**Title:** Advisory Committee on Reactor Safeguards  
Early Site Permit Subcommittee

**Date:** Wednesday, March 8, 2006

Presentation by Exelon, Marilyn Kray . . . . .	6
Introduction, Eddie Grant . . . . .	7
Overview, Dr. Carl Stepp . . . . .	16
Staff's Evaluation of Licensees' Responses to	
Generic Letter 2004-02:	
Introduction, Laura Dudes . . . . .	90
NRC Overview, John Segala . . . . .	93
Performance Based Review, Cliff Munson . .	95

## Conclusion 2 (Cont.)

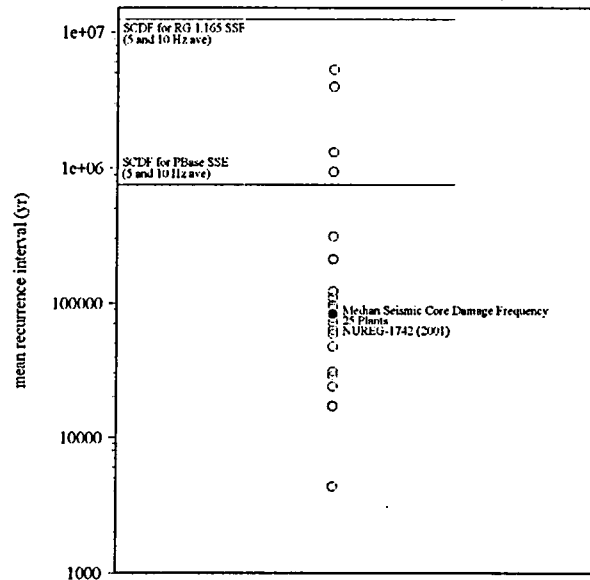
22 DR. BONACA: But doesn't Figure 29 -- the  
23 Figure 29 shows that the performance based approach is  
24 still conservative with respect to the current plants,  
25 but not as conservative as the one on Reg. Guide
